A PLAT OF HESKETH SOUTHWEST

ITEM 4 - HESKETH SOUTHWEST

KPB File No.	2022-135
Plat Committee Meeting:	September 26, 2022
Applicant / Owner:	Bradley Kloeckl of Homer, AK
Surveyor:	Christopher Mullikin / Mullikin Surveys
General Location:	Remote, Hesketh Island

STAFF REPORT

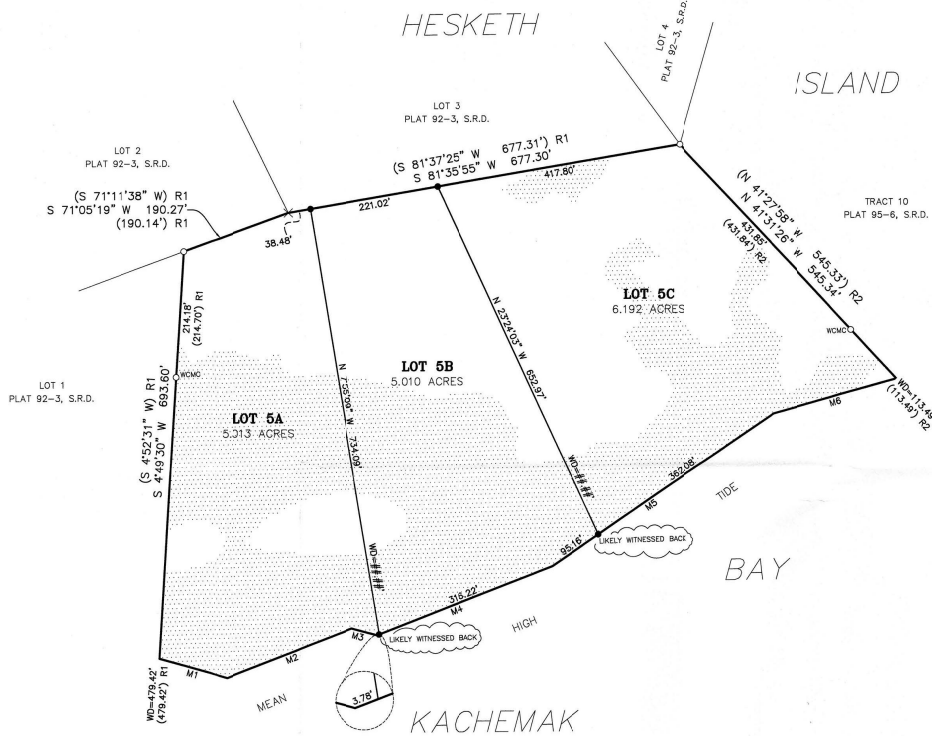
Site Investigation: KPB does not have any wetland or contour information for the area. A contour map was obtained from USGS National Website to get a better idea of the terrain of the plat. The plat does identify areas of steep terrain over 20% grade. **Staff recommends the steep terrain remain in the final plat and the wetland determination remain.**

The only improvement apparent is a building that per KPB GIS imagery, is within the southeast portion of proposed Lot 5C. The imagery available for the area is older. **Staff recommends the surveyor must verify that the subdivision plat will not create any encroachment issues, if found they must be disclosed to staff with statement of resolution.**

The subdivision is within a non-regulatory floodplain. Plat note 4 does indicate the possibility of inundation. **Staff recommends the area be depicted within a reference to the plat note.**

- *The Mullikin Surveys label above the title block is not required as the information is in the title block. If trying to include company logo, it can be incorporated into the title block or may remain.*
- *If no easements are being granted or of record, the line should be removed from the legend.*
- *The line symbol for neighboring lot lines should be added to the legend.*
- *Add to the legend the definition of "WD".*

Staff recommendation: The name of the subdivision should include the parent name. Suggested would be Hesketh Island Adventure Southwest or Hesketh Island Adventure 2022 Replat or Kloeckl Replat. The location of the subdivision can be listed as SW1/4 SE1/4. Add the KPB File number 2022-125 to the drawing. Correct the owners name to as shown on the KPB website and per Certificate to Plat.

- C. The location, width, and name of existing or platted streets and public ways, railroad rights-of-way, and other important features such as section lines or political subdivisions or municipal corporation boundaries abutting the subdivision;
Staff recommendation: Section lines should be shown and labeled.
- I. Approximate locations of areas subject to tidal inundation and the mean high water line;
Staff recommendation: Add a line across the lots, for the tidal inundation with label or reference to plat note.

- Per the Certificate to Plat there are covenants on file for the subdivision. Provide the following plat note, "Subject to covenants, conditions, and restrictions as found within instrument recorded on May 12, 1992 in Book 32 Page 519, Seldovia Recording District.

- The borough will not enforce private covenants, easements, or deed restrictions per KPB 20.60.170.
- The natural meanders of mean high water line is for area computations only, the true corners being on the extension of the sidelines and the intersection with the natural meanders.

- The parent plat contained the note that should be carried over. "The State of Alaska requires that all wastewater disposal systems be a minimum of 100 feet from any water source."

- WASTEWATER DISPOSAL: Lots which are at least 200,000 square feet in size may not be suitable for onsite wastewater treatment and disposal. Any wastewater treatment or disposal system must meet the regulatory requirements of the Alaska Department of Environmental Conservation.

- Per KPB 20.30.050 Legal Access, the mode of access for this subdivision is by watercraft.

Plat note 5 may be removed unless utility easements are granted.

Plat note 8, reword as they are considered exceptions to code. This note may be removed if the plat committee concurs with staff's recommendations.

Staff recommendation: The owner's name must match the deed as shown in the Certificate to Plat. Comply with 20.60.190.

Staff recommendation: It appears witness markers will be used and the plat will be updated. There is an X being shown along the northern boundary. Per the parent plat this should be a found monument that is for the northern lot line along this subdivision's boundary where the bearing changes. Verify location and if the X remains add to the legend. Comply with 20.60.200
